Figure 1: 5 GHz contour plot entire device

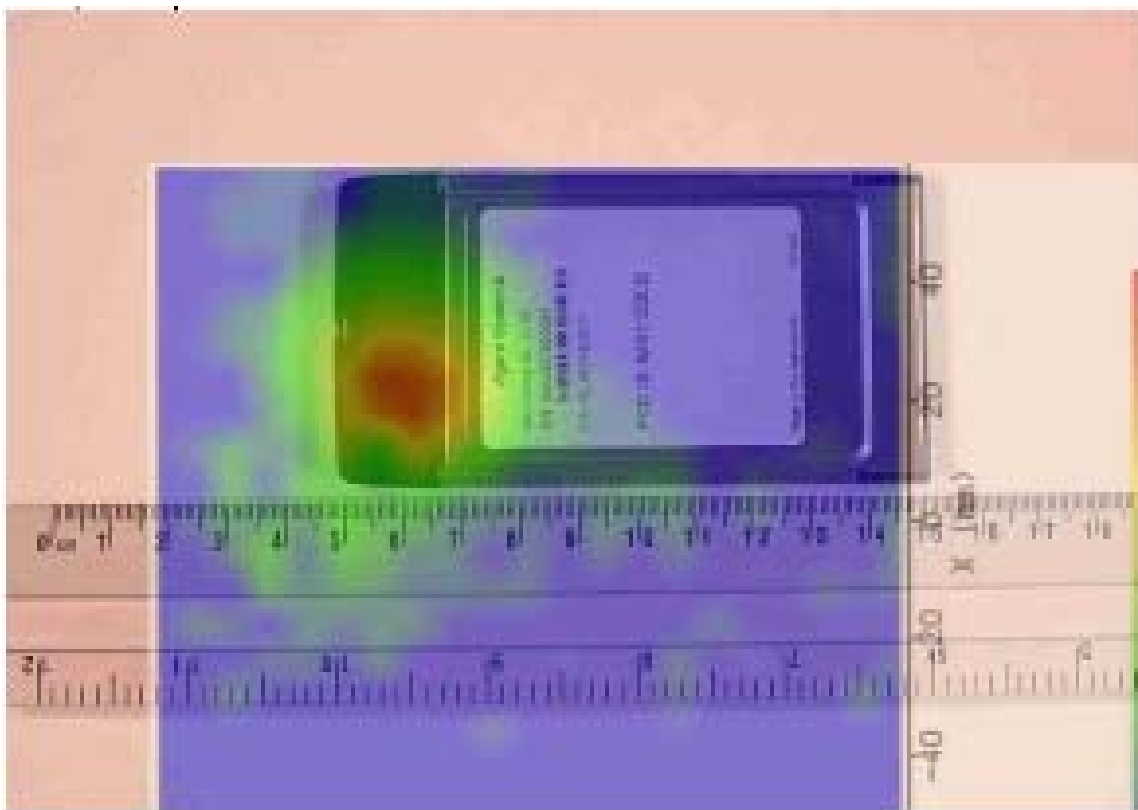
5) SAR plots entire device

Figure 3 channel 149 lapheld

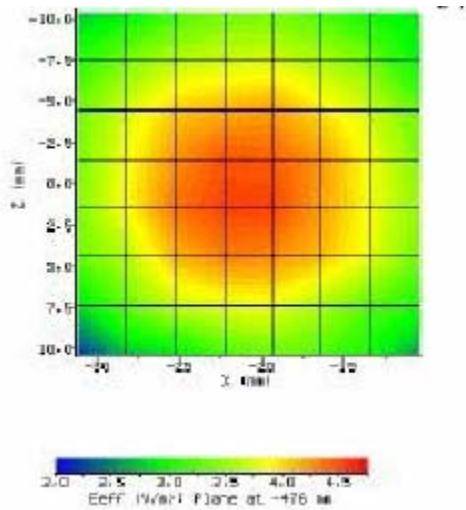
6) Contour plots:

Please find below the missing plots
